**RE: West Santa Inez Condominiums**

I visited the site and have prepared multiple review letter in the last several months. My comments on the revised drawings are as follows:

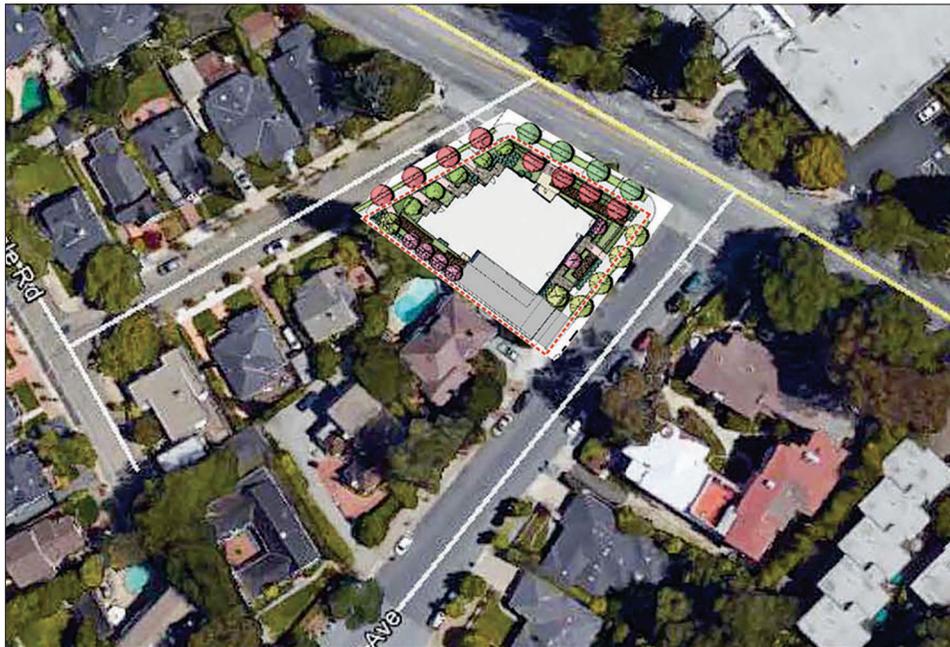
The proposed development has a relatively small footprint and would be surrounded by substantial landscaping - see landscape plan superimposed on the aerial photo below.

#### PARKING ACCESS AND LAYOUT

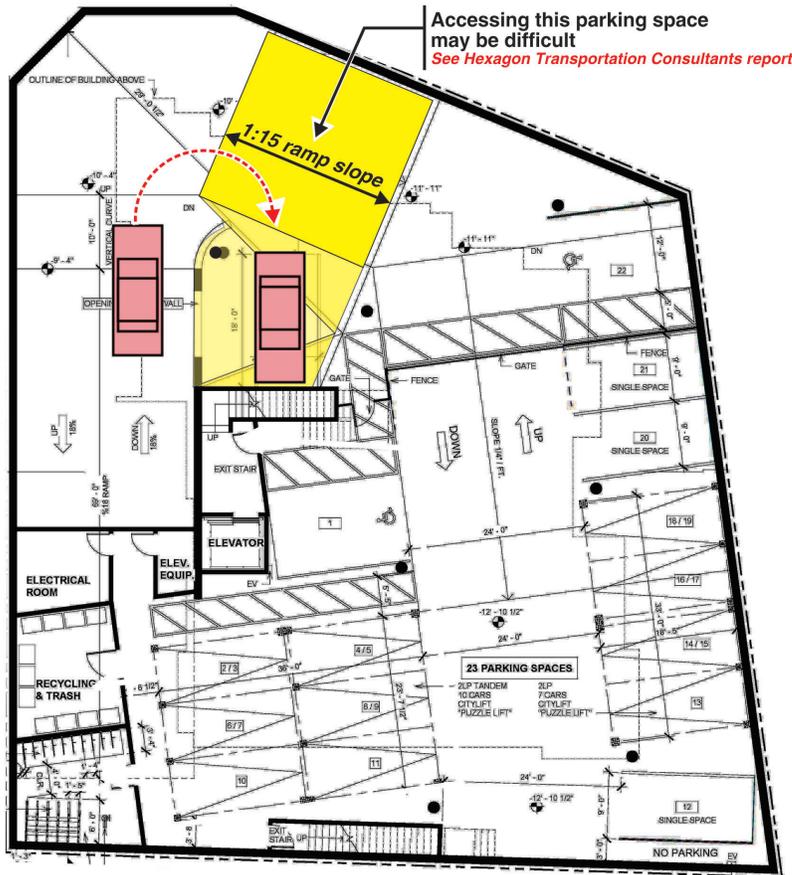
In my earlier review letters, I drew attention to three issues related to the garage.

1. Accessing the parking at the turn located at the bottom of the garage access ramp may be difficult - see illustration below. This issue has also been highlighted in Hexagon Transportation Consultants report:

*The underground parking garage would be accessible from a single full access driveway on West Santa Inez Avenue in the southwest corner of the project site .... There are one standard parking stall and one handicapped stall shown outside the gate. The standard stall is shown to be accessed from a ramp with a slope of 1 in 15 (6.67%). While this conforms to the maximum allowable slope for parking spaces, it would involve making a multiple point turn to access the parking space.*

Substantial changes were made to the garage since my original review letter including an improved internal pedestrian link and the addition of a pony wall for visibility into the guest parking space.

## ELEVATIONS

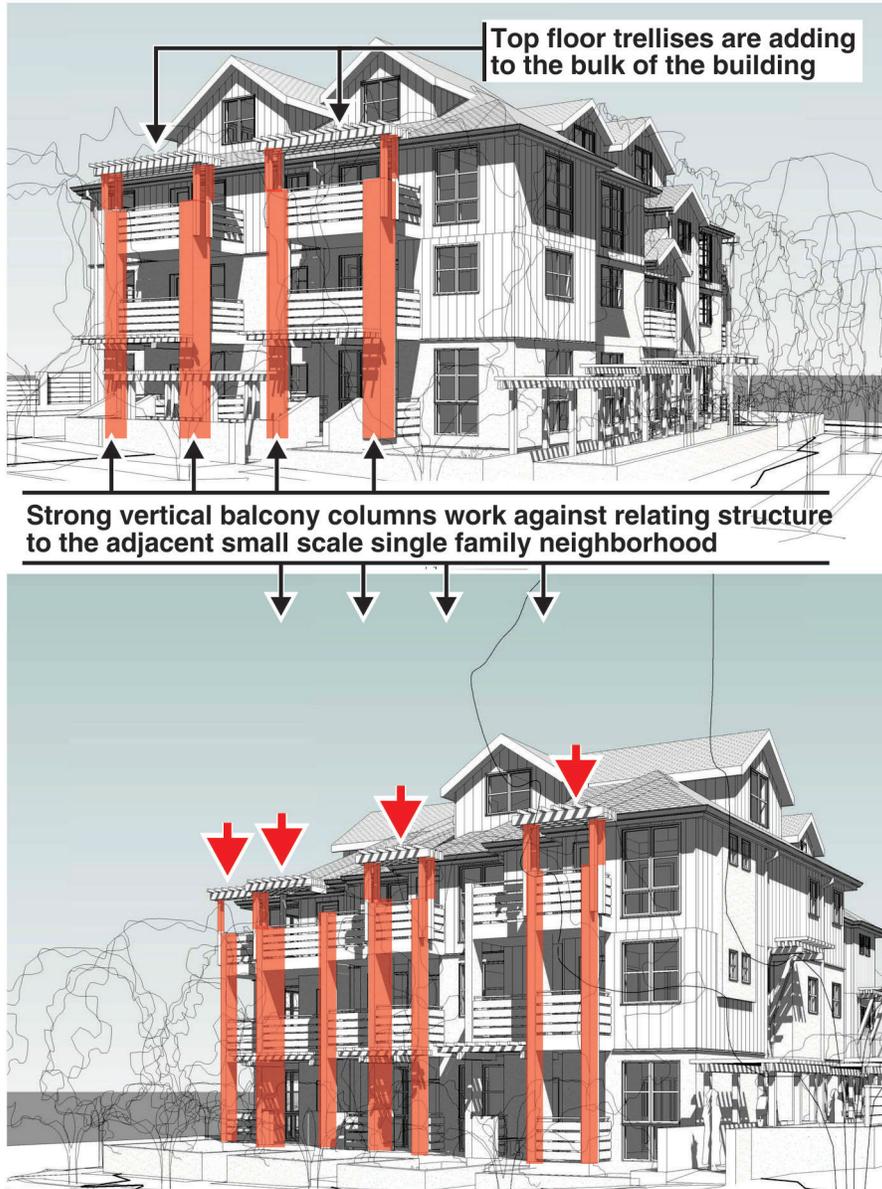
1. The strong vertical emphasis created by the stacked balconies with continuous vertical supports and top floor posts supporting the trellises makes the building appear taller, and more difficult to relate this larger structure to the adjacent small scale single family homes..
2. The top floor trellises are adding bulk to the building which is also working against creating a good relationship with the adjacent homes.

1. Revise the balconies to provide more of a horizontal emphasis - see illustrative recommendations below.
2. Remove all top floor trellises.
